## Response to AIR

## ADDITIONAL INFORMATION

Pacific Gas and Electric Company  
Kilarc-Cow Creek Hydroelectric Project, FERC Project No. 606

Figure 1. Regional Groundwater Basin and Old Cow Creek above the Kilarc Diversion Dam Watershed

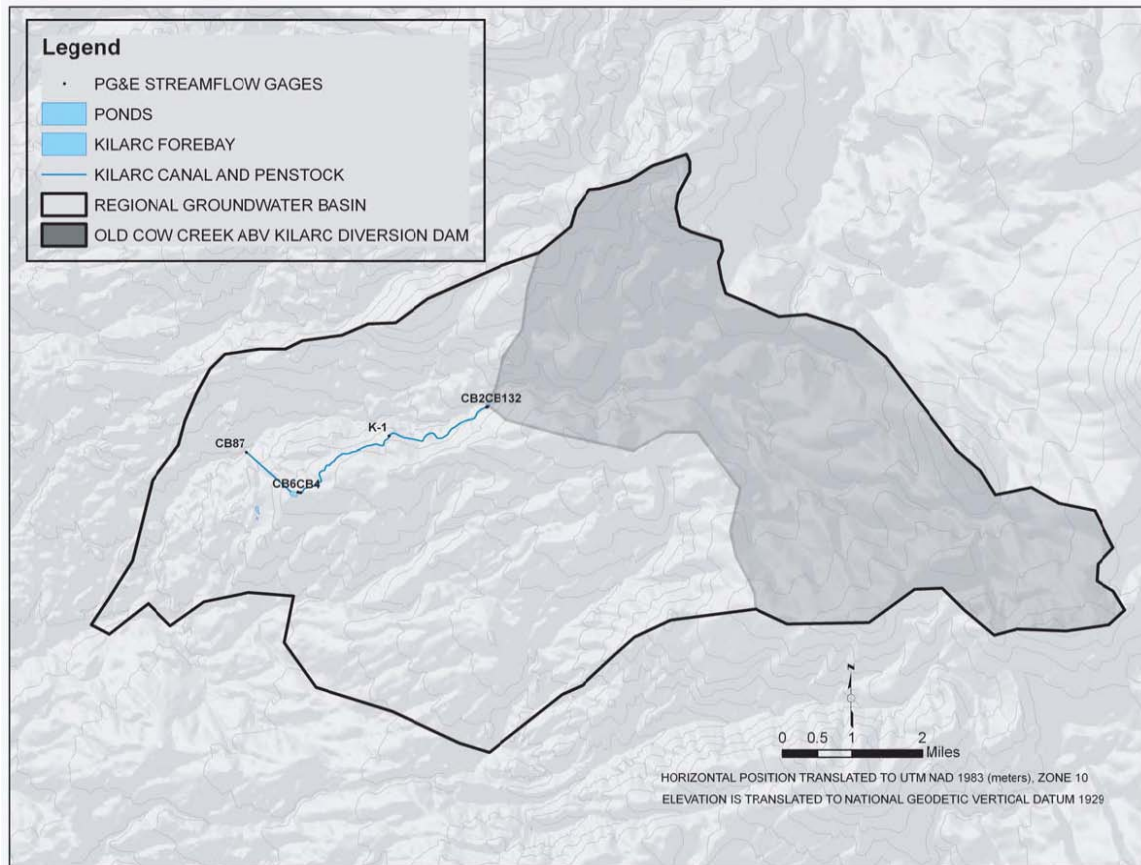
***Water Resources Item 4:*** Please provide information, including any available data, regarding the hydrogeology and groundwater resources in the project area that might be reasonably influenced by the Kilarc forebay. Please discuss the potential impacts of dewatering the Kilarc forebay on local groundwater resources.

The regional groundwater basin consists of 39,715 acres that range from approximately 2,000 feet to 5,200 feet above mean sea level (MSL) as shown on Figure 1. The aerial extent of the regional groundwater basin boundaries were determined by delineating the topographic divides between adjacent watersheds. The groundwater basin was assumed to be coincident with the topographic drainage basin.
